From Tegwch Resident's Committee

Date: 20 June 2023

RE: 171 Graig Road, Godre'r Graig, Ystalyfera, Swansea (Formerly Godre'r Graig Infants School)

Note on Residents' Report (Tegwch) presented in: Questions and Comments on Tip 2 Stability Reports - 171 Graig Road, Godre'r Graig, Ystalyfera, Swansea - Formerly Godre'r Graig Infants School and NPTCBC note of 25.04.2023.

Figure 2.1.2-1: Spatial Distribution of Shearbox Laboratory Test Data

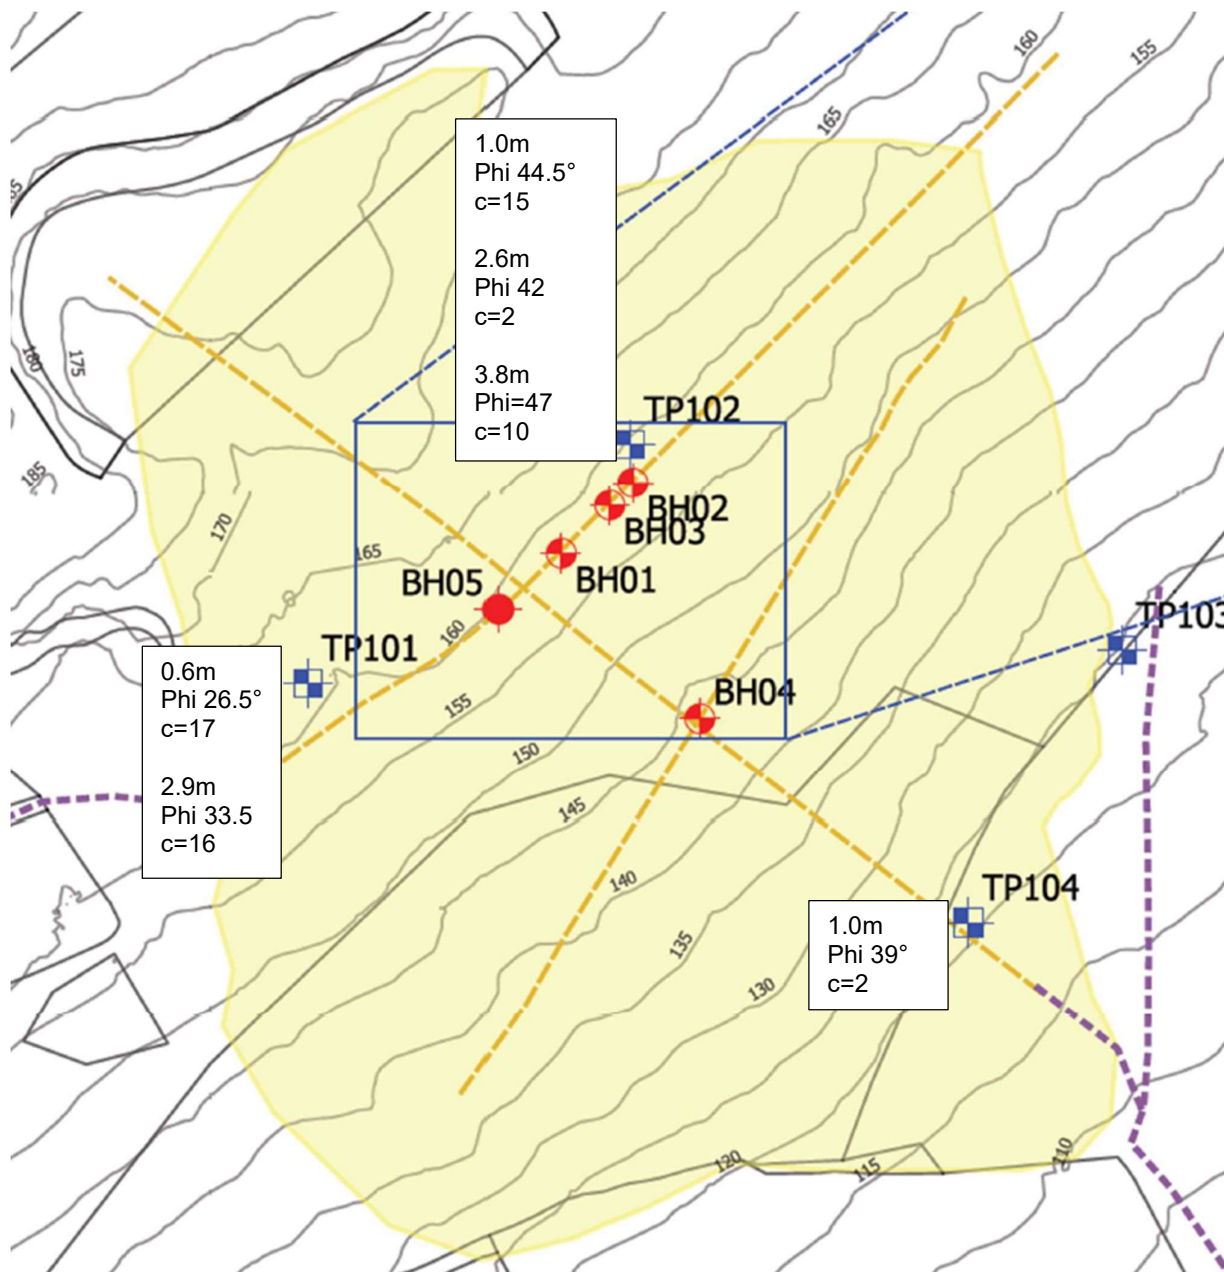
We have been unable to find any comment on the spatial distribution of the laboratory tests relative to provenance, either in lateral extent or depth (TP102 showed Φ values greater than 40° . Only one sample returned a ϕ angle lower than 30° , and that was taken at 0.6m depth (TP101)). Would this isolated value be considered a critical factor in a rapid landslide of 500m^3 or greater?

Does NPTC consider cohesion a valid property for boulders and cobbles (or even gravel)? If the shear box tests were to be re-analysed with cohesion = 0 then the phi angle would be increased further. There are schools of thought that cohesion will decrease to zero over decades or cohesion could be lost if there is movement in the slope.

Noting that a large shearbox was used in the laboratory testing: Why was the samples' 20mm minus fraction tested when larger particle sizes may have given a more representative estimation of tip strength and can be used in a large shearbox? Although it is unlikely that all particle sizes of 'large gravel', cobbles, or boulders would have been tested.

Figure 2.5.2 – Made Ground Depths

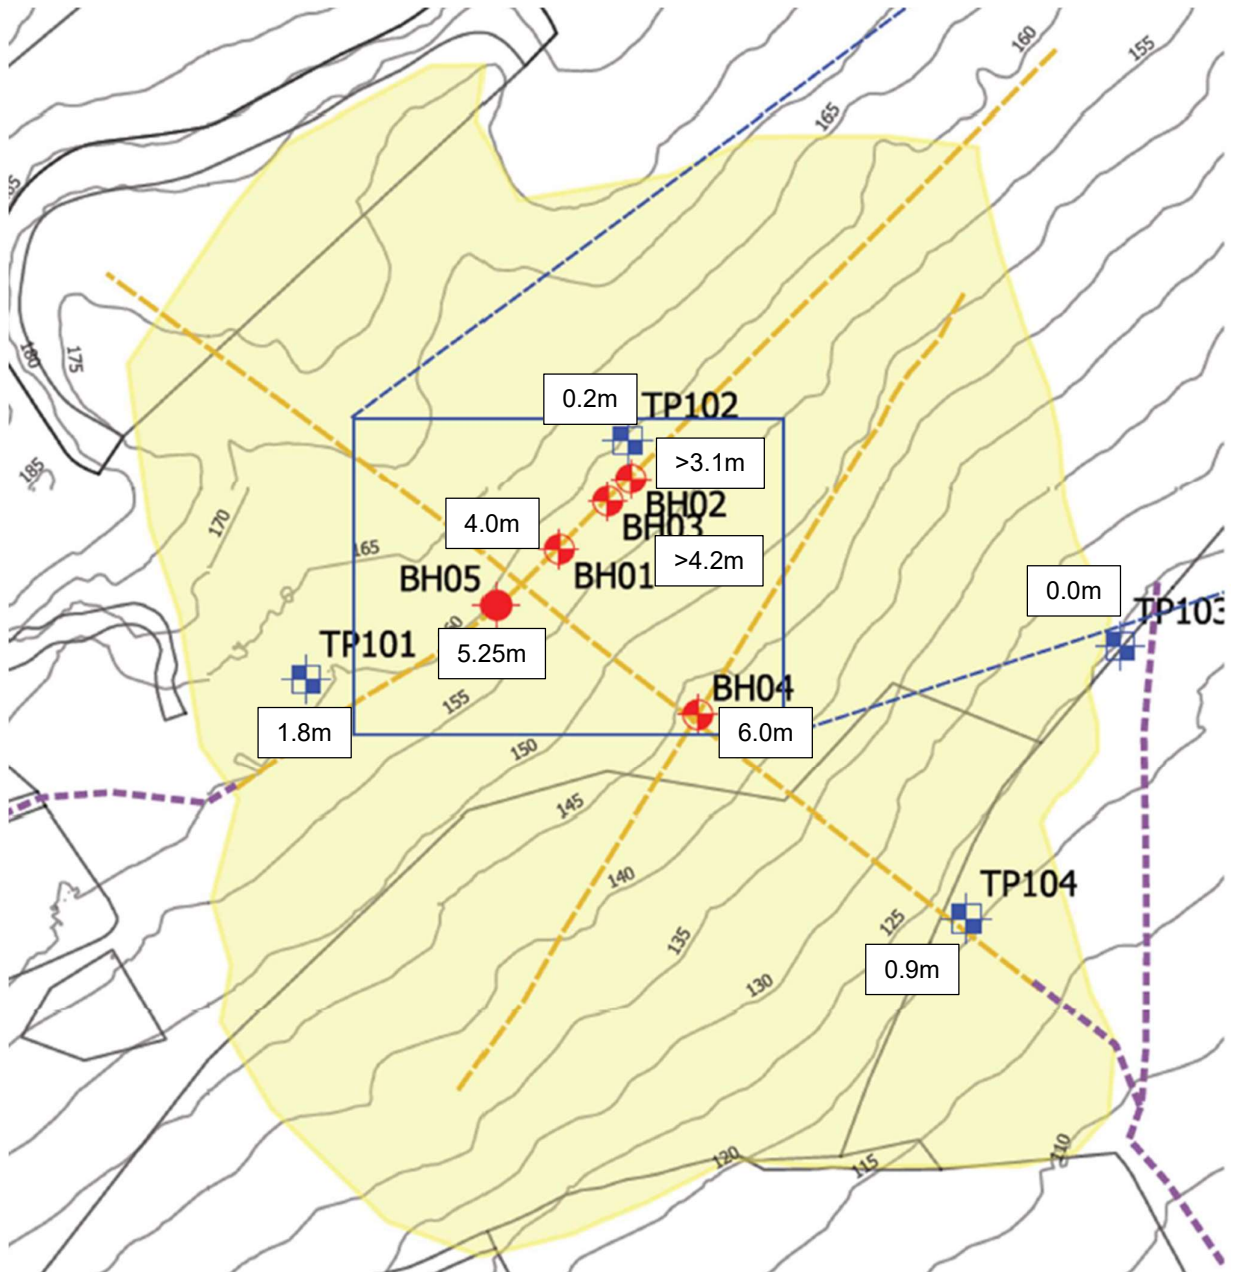
As the purported tip volume ($>87,000 \text{ m}^3$) plays a significant factor in enabling removal/betterment work, the assessment of cost options are also equally questionable. We refer NPTC to Tables 3.13-1 (no thickness of coarse discard greater than 2.9 m and Table 3.13-3 Borehole Made Ground thickness. These data have been presented in Figure 2.5-2 below. The thickness of the coarse discard are presented adjacent to intrusive investigation locations (trial pits and borehole data). It appears that the thickness should be significantly less than the 5m across the mapped extents of the tip.

Using basic averages (mean) gives a thickness of 3.6 (assuming depth of 5.5m for BH02 and BH03) this then tapers to the edges (factor of 0.5) may present average thickness of 1.8 m.

The deflection in contours suggest a smaller tip outline.
